Contract #: 04-0120F4Cty: SF/ALA Rte: 80 PM: 13.2/13.9File #: 69.25B**QUALITY ASSURANCE -- NON-CONFORMANCE REPORT****Location:** Changxing Island, Shanghai, P.R. China**Report No:** NCR-000744**Prime Contractor:** American Bridge/Fluor Enterprises, a JV**Date:** 26-May-2010**Submitting Contractor:** Zhenhua Port Machinery Company, Ltd (ZPMC), Changxing Island**NCR #:** ZPMC-0707**Type of problem:**

**Reference Description:** Work performed without an approved WPS on Bikepath Assembly BK004A-008, 010, 011

**Dear:** Mr. Charles Kanapicki  
**Job Name:** SAS Superstructure

**Subject:** NCR No. ZPMC-0707

**Reference Description:** Work performed without an approved WPS on Bikepath Assembly BK004A-008, 010, 011

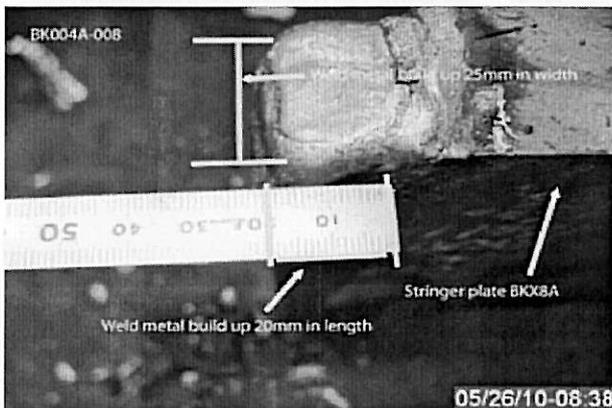
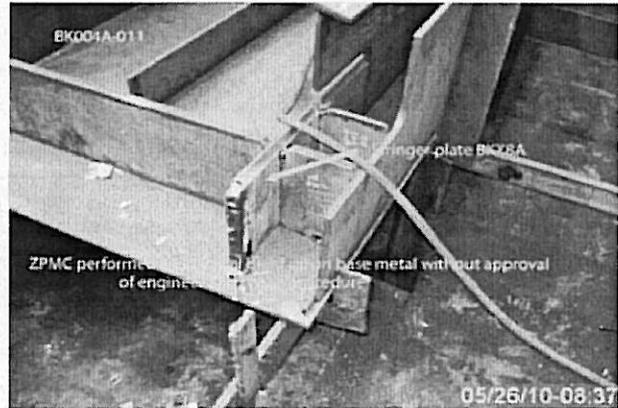
During random in-process observation of the fabrication for bikepath BK004A-008, BK004A-010, and BK004A-011, this Caltrans Quality Assurance (QA) Inspector discovered the following issue:

- Weld Build up (Buttering) performed without following an approved WPS.
  - The buttering was performed by sandwiching the end of the material between two ceramic backing bars, one on each side of the plate and filling the square groove created by the backing bars with weld metal in the vertical position.

- The amount of buttering was approximately 20mm deep, 25mm wide, and over the full height of the edge.
  - The members affected are identified as stringer plates BKX10A and BK8A on bike path assembly BK004A-008.

- Stringer plates BKX9A and BKX8A on bike path assembly BK004A-010.
  - Stringer plates BKX10A and BKX8C on bike path assembly BK004A-011.
  - ZPMC Quality Control (QC) provided Caltrans QA with Weld Repair Report (WRR) B-WR13162 for review.

- The WRR did not describe the use of the two ceramic backing bars, and the details of the use of steel backing and joint preparation.
  - The WPS mentioned in the WRR were not utilized.

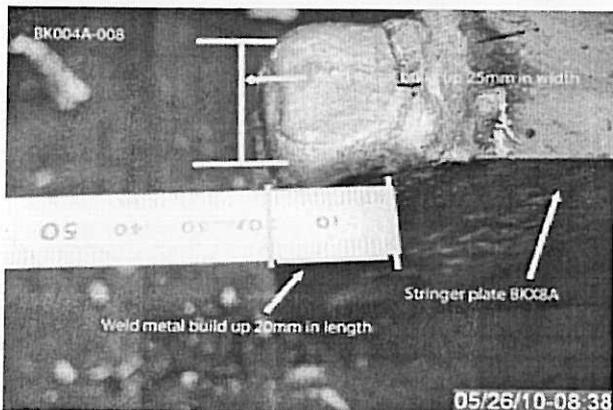
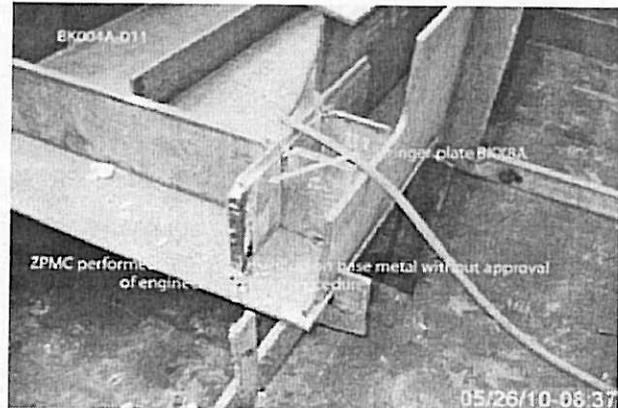
During random in-process observation of the fabrication for bikepath BK004A-008, BK004A-010, and BK004A-011, this Caltrans Quality Assurance (QA) Inspector discovered the following issue:

- Weld Build up (Buttering) performed without following an approved WPS.
- The buttering was performed by sandwiching the end of the material between two ceramic backing bars, one on each side of the plate and filling the square groove created by the backing bars with weld metal in the vertical position.

- The amount of buttering was approximately 20mm deep, 25mm wide, and over the full height of the edge.
- The members affected are identified as stringer plates BKX10A and BK8A on bike path assembly BK004A-008.

- Stringer plates BKX9A and BKX8A on bike path assembly BK004A-010.
- Stringer plates BKX10A and BKX8C on bike path assembly BK004A-011.
- ZPMC Quality Control (QC) provided Caltrans QA with Weld Repair Report (WRR) B-WR13162 for review.

- The WRR did not describe the use of the two ceramic backing bars, and the details of the use of steel backing and joint preparation.
- The WPS mentioned in the WRR were not utilized.
